Project: 20181 Clonburris Phase Tile 3 - Daylight, Sunlight & Overshadowing (DSOR)

I hereby write to you in response to request for further information with regards to the following project, 20181 Clonburris Phase Tile 3 – SDZ22A/0017. Specifically, to Item no. 5 (b):

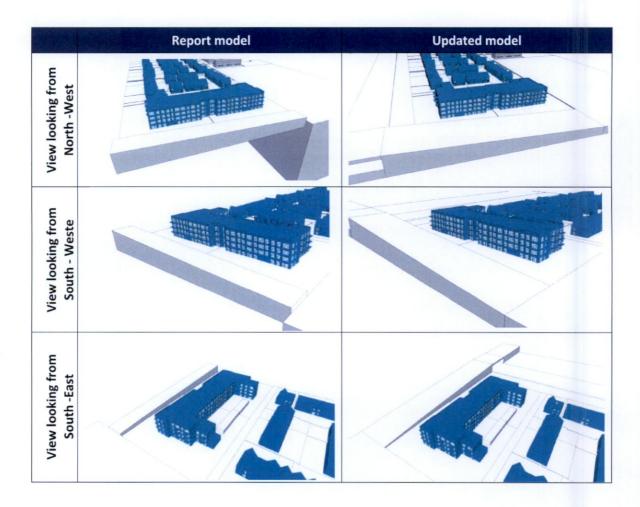
"The applicant is requested to set out how the proposed bridge has been taken into consideration in the sunlight and daylight assessment. A 'worst case' scenario should be utilized to ensure the impacts on future development are fully assessed."

It should be noted that the original model used for analysis which results were produced from to form the report for Clonburris T3 submitted on the 22/11/2022 did allow for a representative massing of the bridge. Although this is true, the bridge had been remodeled and the analysis rerun to assess the latest bridge design and any potential impacts it may have with regards to daylight and sunlight.

The images in the following table compare the previous report model and updated massing of the new bridge.

#### 4.1. Sunlight to Proposed Amenity Spaces Results

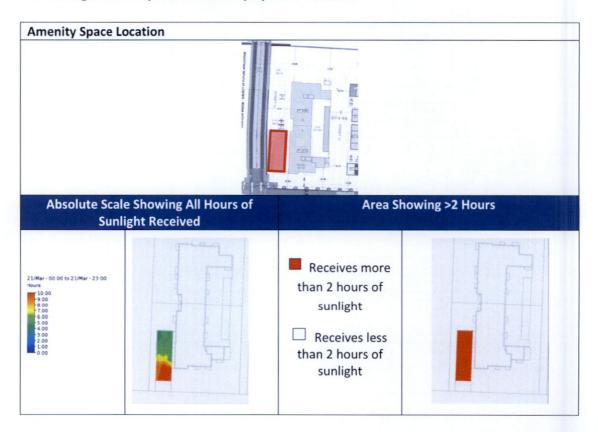
An assessment was carried out on the amenity space to the west of the site between the apartment block and the road/bridge with the updated bridge design in place.

On March 21<sup>st</sup>, 100% of the amenity space situated between the proposed apartment block and the road/bridge to the west will receive at least 2 hours of sunlight over its total area, thus complying with the BRE recommendations to a very high standard with the new bridge design in place.
